**RE: Montoya Street Townhomes (File: H12D019A)
Tracts A1 and A2 Lands of David Maciel
Montoya St NW between Floral Rd and I-40
Grading Plan and Drainage Report
Engineer's Stamp Date – 12/16/2015**

RE: **Montoya Street Townhomes (File: H12D019A)**
Tracts A1 and A2 Lands of David Maciel
Montoya St NW between Floral Rd and I-40
Grading Plan and Drainage Report
Engineer's Stamp Date – 10/15/15

Based upon the information provided in your submittal received 10-15-15, the above referenced Grading Plan and Drainage Report cannot be approved for Preliminary Plat, Final Plat and Grading Permit until the following comments are addressed.

<p>ENGINEER'S SEAL</p> <p>DAVID SOLE</p> <p>10/15/15</p> <p>DAVID SOLE</p> <p>P.E. #14322</p>	<p>MONTOMOYA STREET TOWNHOMES</p>	<p>DRAWN BY: WCM/J</p> <p>DATE: 10-15-15</p> <p>21523-LAYOUT-B-08-10</p>
	<p>GRADING AND DRAINAGE PLAN</p>	<p>SHEET #</p> <p>---</p> <p>JOB #</p> <p>21523</p>

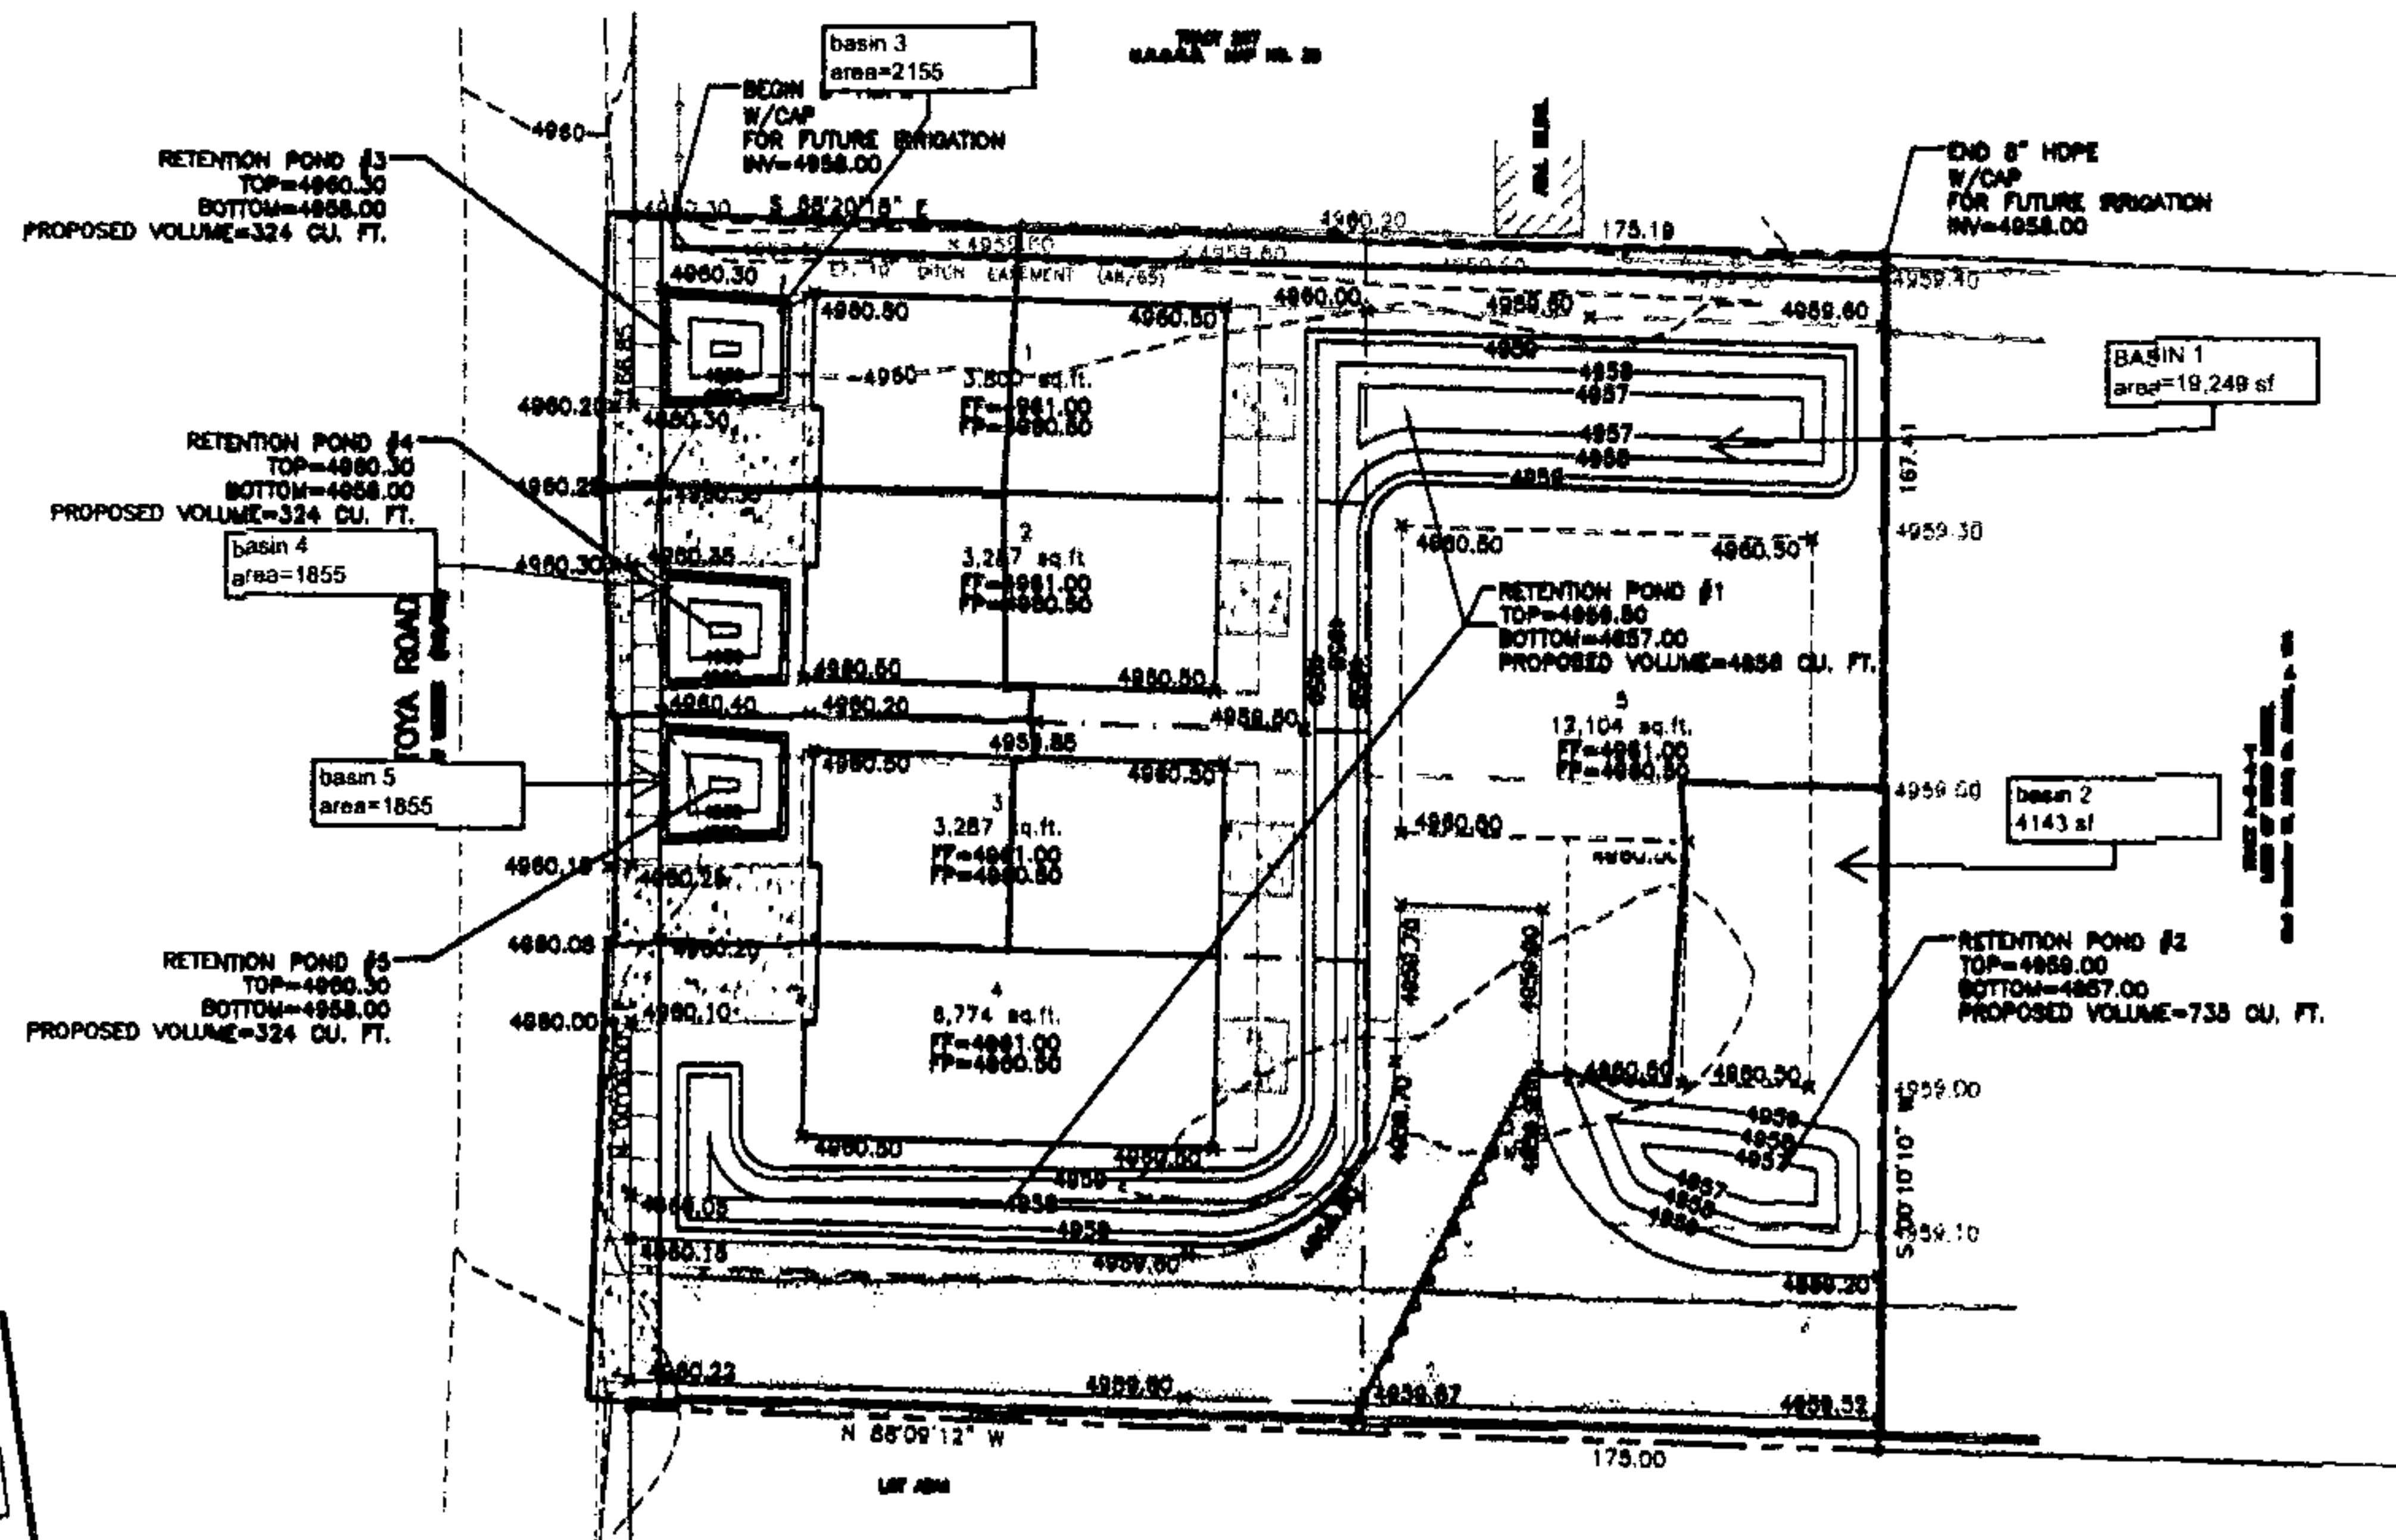
- Provide drainage flow areas to better identify overall site drainage patterns. **ADDED BASIN MAP** ✓
- Provide roof flow direction and outfall locations. **ADDED TO PLAN** ✓

- Clearly identify and define property lines. **"** ✓
- Clearly identify the location and limits of the 10 ft Ditch Easement located on the north property line. **"** ✓

- The Drainage Report indicates flows from a storm event exceeding the 100-yr, 6 hr storm event will discharge to Montoya Street. Per the spot elevations identified on the Grading Plan, it appears flows will be directed east away from Montoya Street. Show on the Grading Plan how this will be achieved. **REVISED REPORT TO CORRECT** 10-DAY

- The Drainage Report states the platting action will allow for cross lot drainage easement on all parcels yet the Drainage Report identifies flows to be retained onsite or discharged onto Montoya Street during a larger design storm. Provide offsite flow information and how offsite flows will be managed onsite. **ADDED BASIN MAP**

- A scale check on the area for townhomes 1-5 appears as though the area provided is incorrect. Re-check the areas to ensure the information is correct. **CORRECTED**
